# ADDENDUM NO. 3

### November 28, 2022

# JACKSON ELEMENTARY SCHOOL RENOVATIONS Valparaiso, IN 46304

This Addendum consists of page ADD 3-1 and attached Addendum No. 3 from Gibraltar Design dated November 23, 2022 and consisting of 7 pages and 42 drawings.

EL103

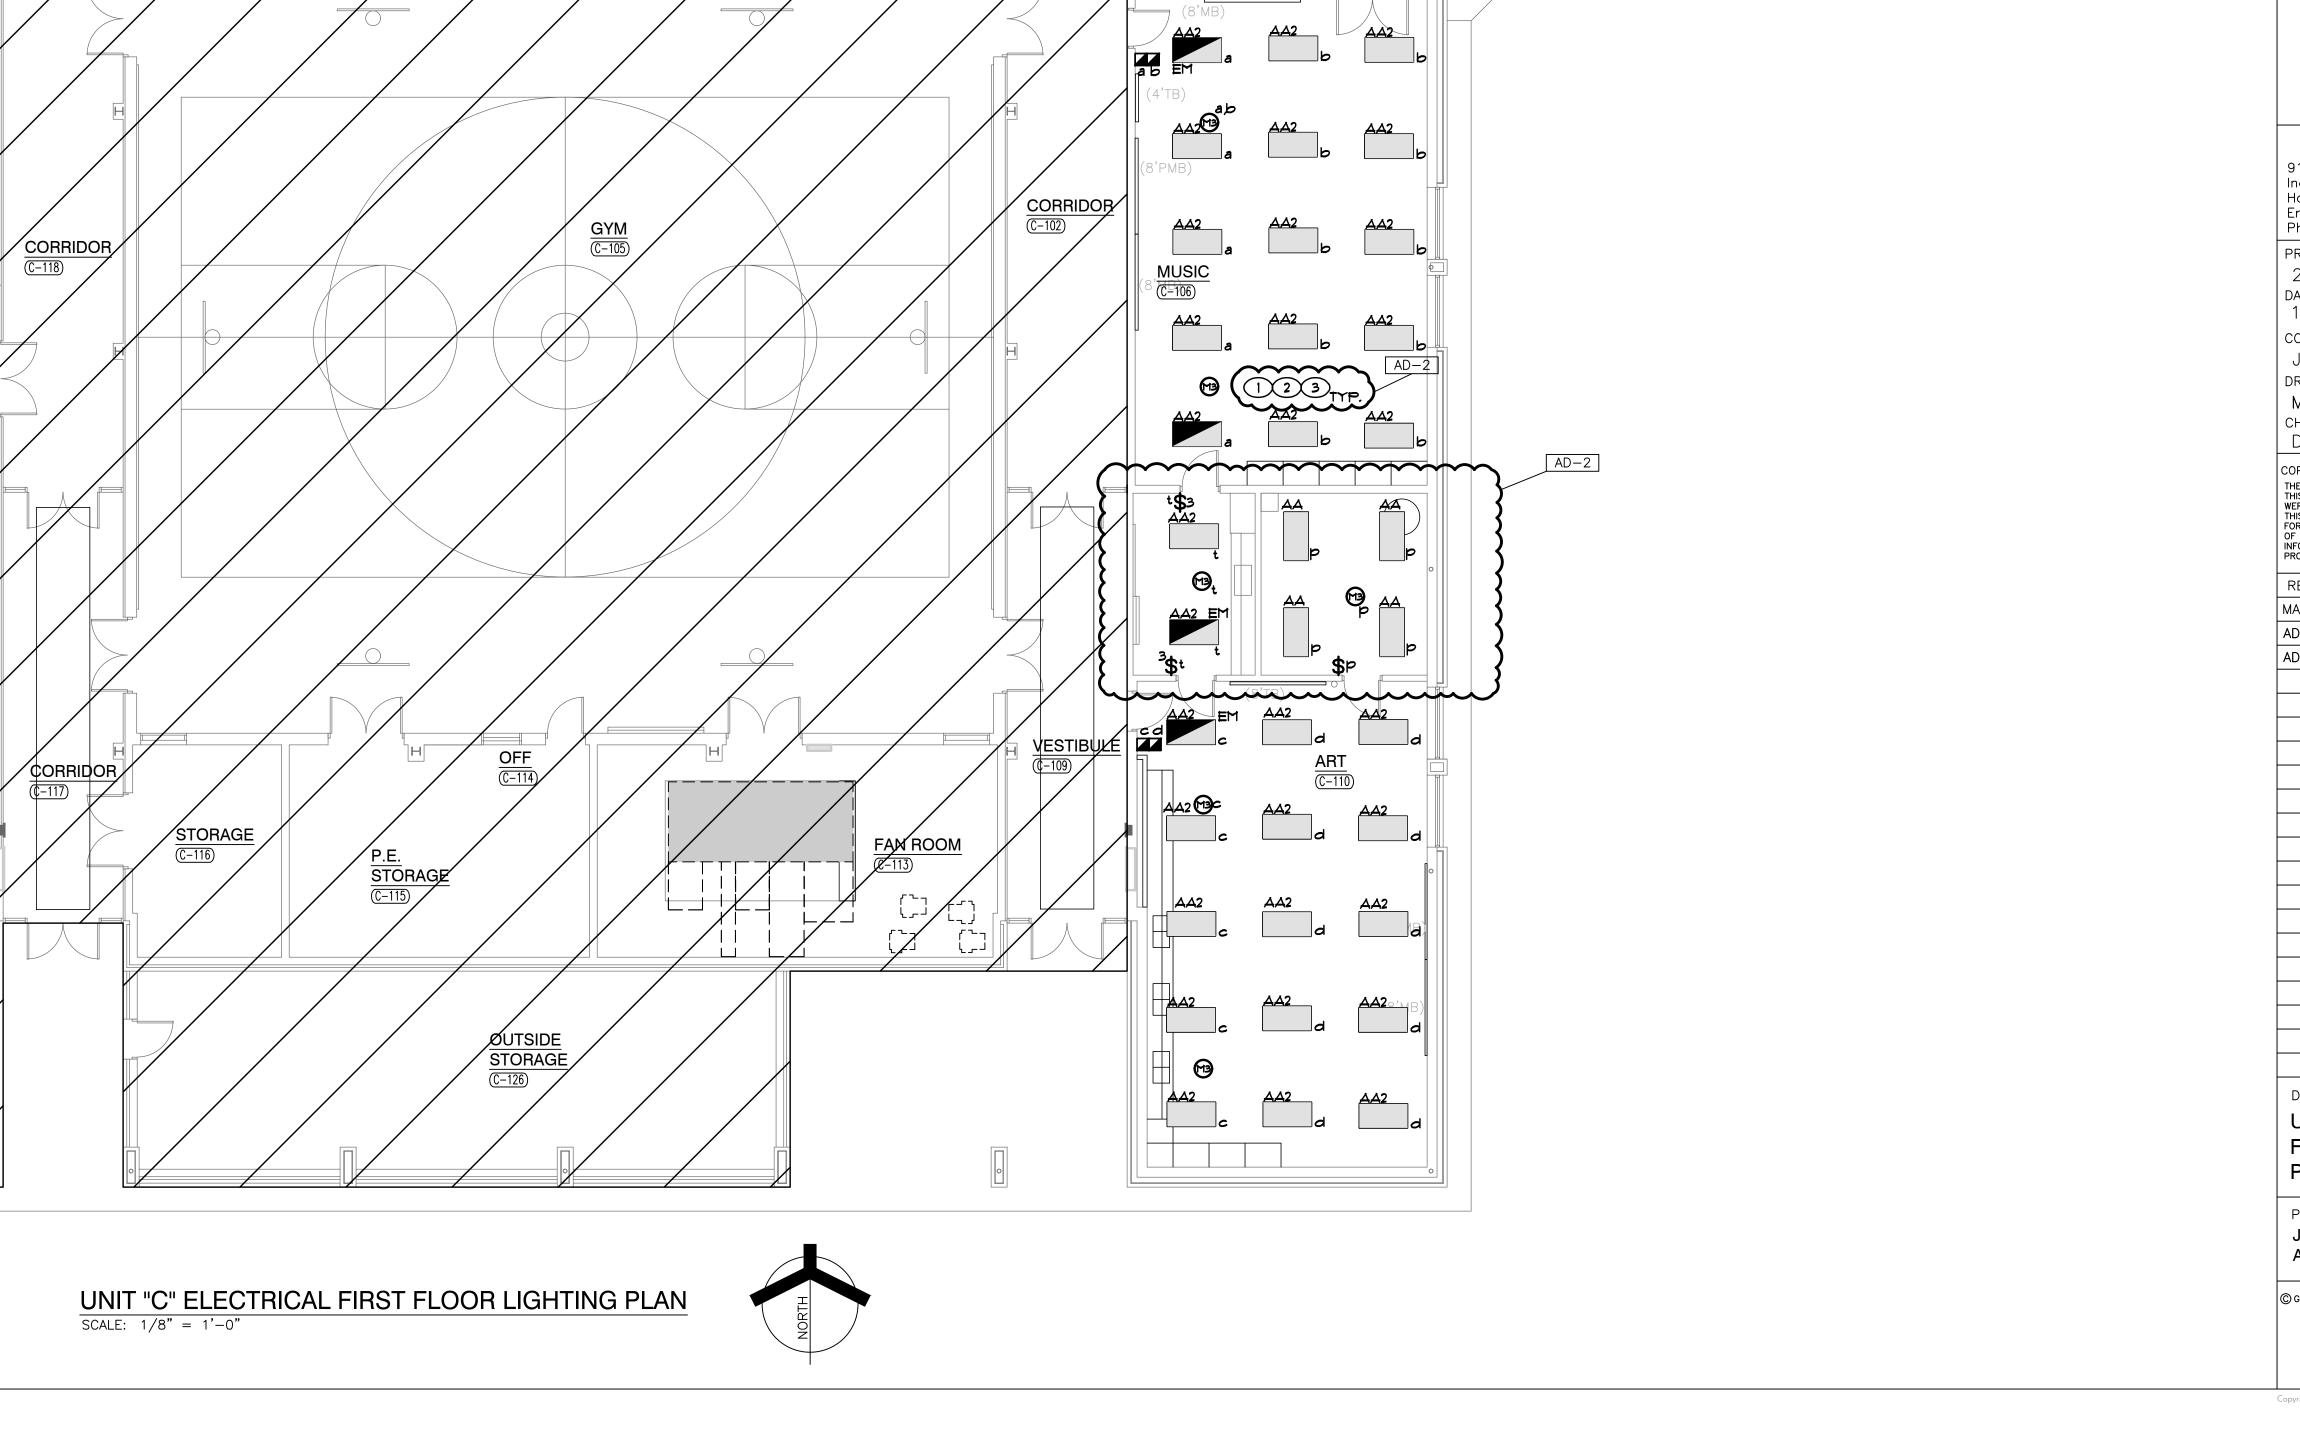
A. Refer to revised full size drawing, included in this Addendum, for added fixture tags.

© GIBRALTAR DESIGN SHEET **EP101** A

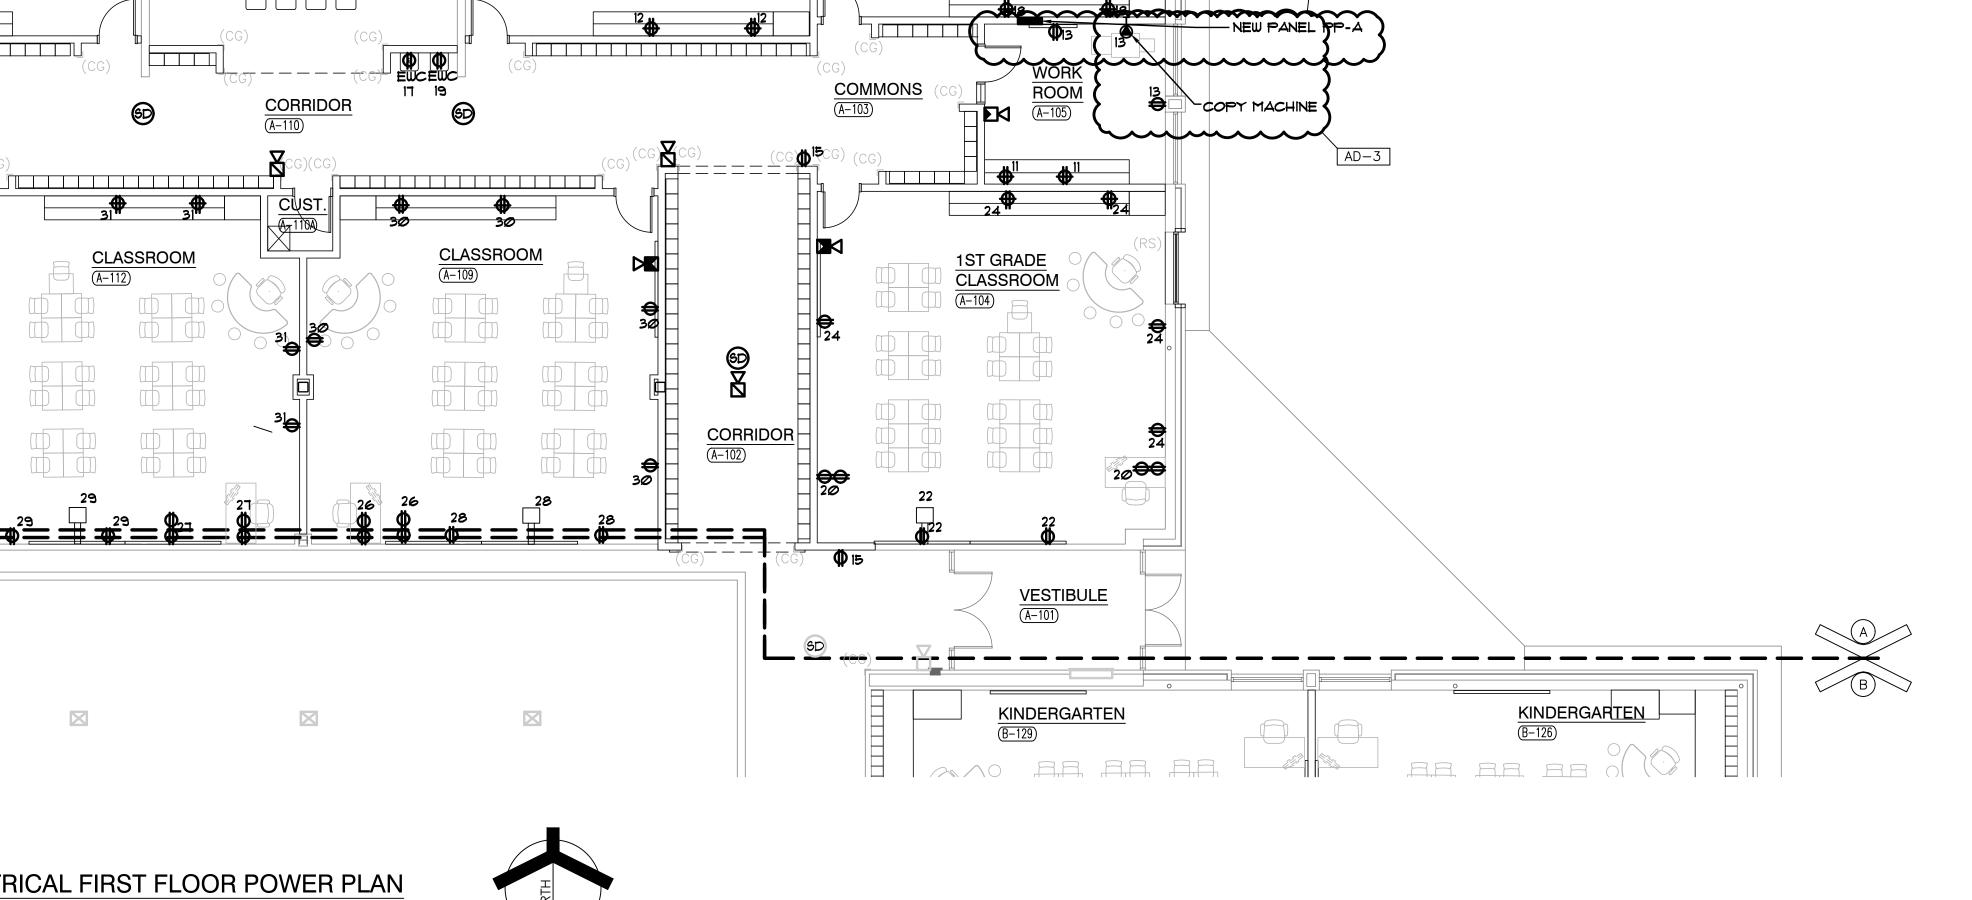
- A. Refer to revised full size drawing, included in this Addendum, for the following revisions:
  - 1. Added power for copier.
  - 2. Adjusted receptacle(s) locations.

EP103

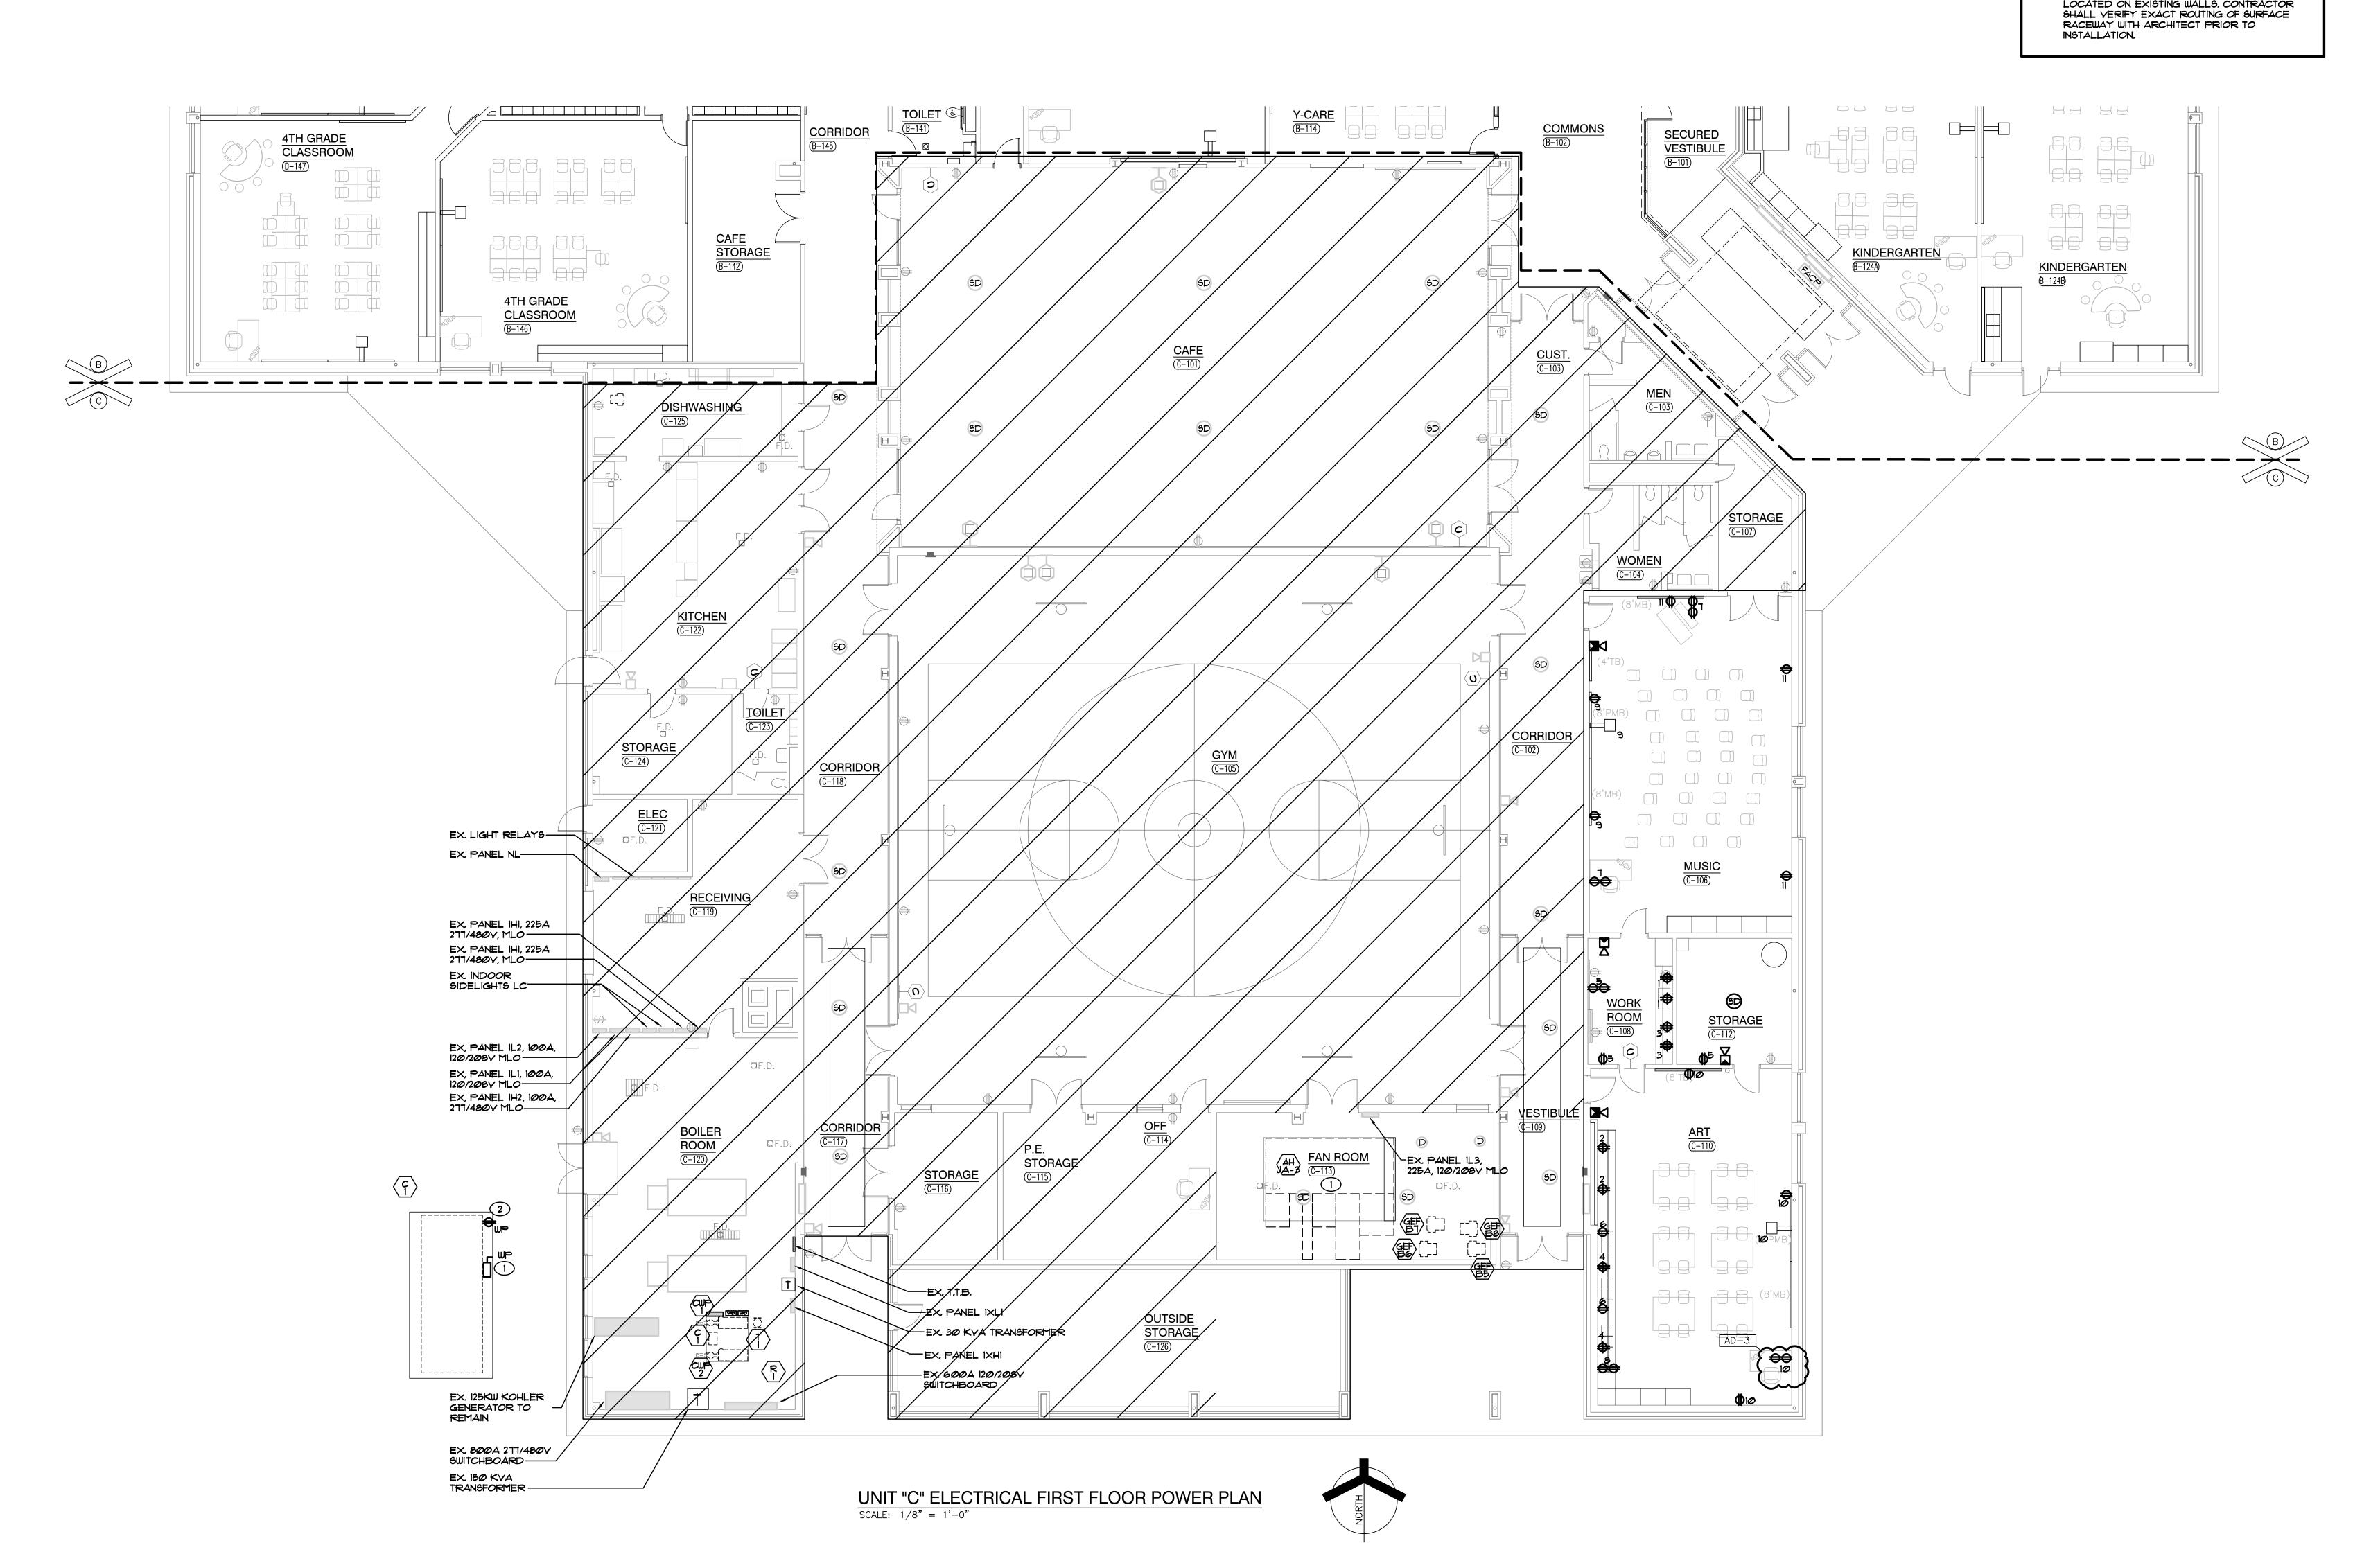
- A. Refer to revised full size drawing, included in this Addendum, for the following revisions:
  - 1. Adjusted receptacle(s) locations.
  - 2. Adjusted hatch.
